Product Change Notification: PCN-22-132403 PCN Date: 15-MAR-22

Tube Package modification for Modular Jack connectors.

# MJ Packaging Improvement PCN (Tube package)

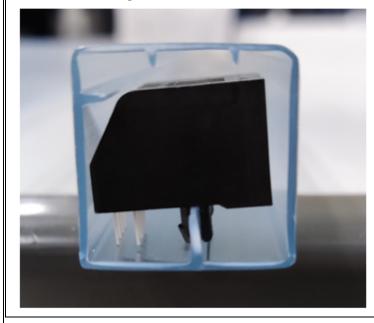
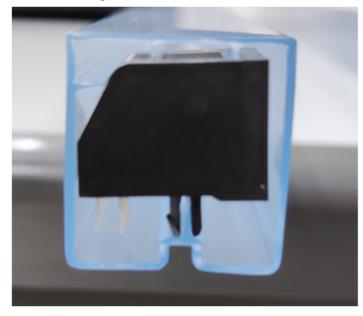
Tube Package modification

#### Current Tube Package

#### New Tube Package

# To improve MJ Tube packaging

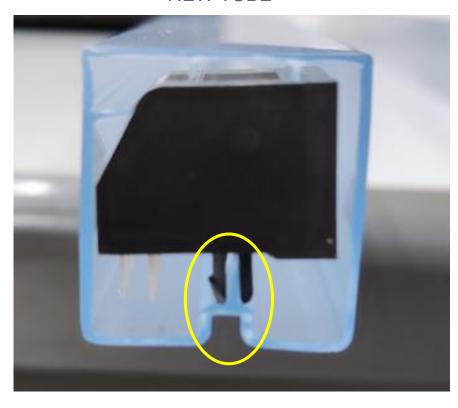
**OLD TUBE**

**NEW TUBE**

- ❖ <u>Description of changes</u>:- Tube Package structure modification.
- \*Reason for change:- "Connector can not smoothly slide out the tube with the tube rib blocking the connectors"
- ❖ Improvement: To change the tube constructure to address the blocking issue in packaging.

Note:- there is no material or function change in part.
